Access Compliance Report

Public Rights-of-Way

Intersection ID: 13247	Main Street: MERRIMAN_AV	Cross Street: W_KINGSTON_AV	Location: SW
ADA ID: 0371BA95333E	Ramp Type: Para	Initial Pass/Fail: Fail	Overall Compliance: No
Codes/Mitigation Info/Possible Solution		Field Measurements/Component Compliance	
Severity Score: 1.25

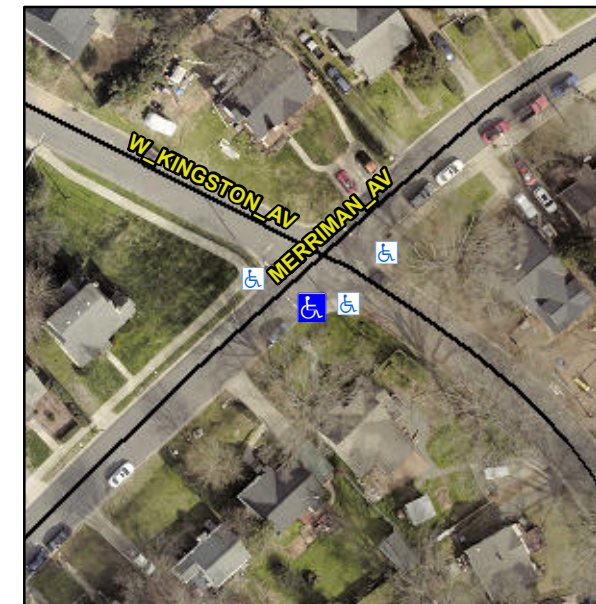
Remove & Replace Entire Ramp.

R304.5.3
